Flying Pig Systems

Wholehog II Expansion Wing Hardware design errors - fixes

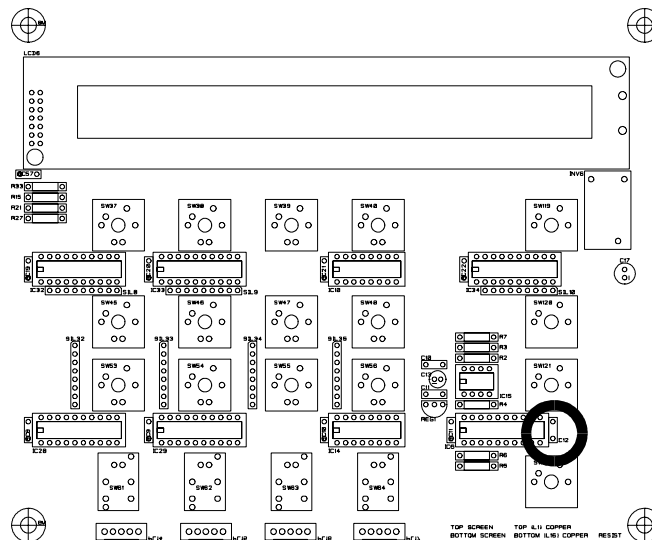
Error #2:

Serial numbers affected by error #2: 0228 - 0260

The faders may not zero correctly or may twitter about zero in hot conditions. This will cause the Flash LEDs to flash or flicker if intensity information present in the assigned Cuelist. The Event Monitor can be used to confirm this condition, you will notice a frequent Wing fader events.

Capacitor C12 should be removed from the PCB by a qualified technician. This modification can be performed **WITHOUT** removing the PCB from the metalwork – consult the diagram below for the whereabouts of this capacitor in the bottom righthand corner of the board.
